July 2016 **Technical Service**

G12 N63R -Ticking Noises From Transmission Cooler Lines Area

G12 (750i/750ix)	Vehicles produced up to 11/15/2015
------------------	------------------------------------

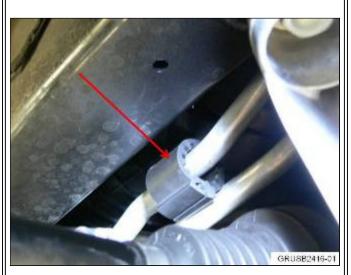
Customer reports an audible clicking noise in the driver's footwell area, heard directly after the transmission shifts.

Interference between the transmission cooling lines and engine support mounts.

Install rubber protection ring on transmission cooler return line.

- 1. Remove front, left wheel.
- 2. Remove the left front wheel arch cover according to Repair Instruction REP 5171 038.
- 3. Install the rubber protection ring (PN 64 53 7 578 706) on the return transmission cooler line, where shown in the illustration.

Note: Applying a small

amount of water on the rubber protection ring, helps to place it at the correct position on the cooler line.
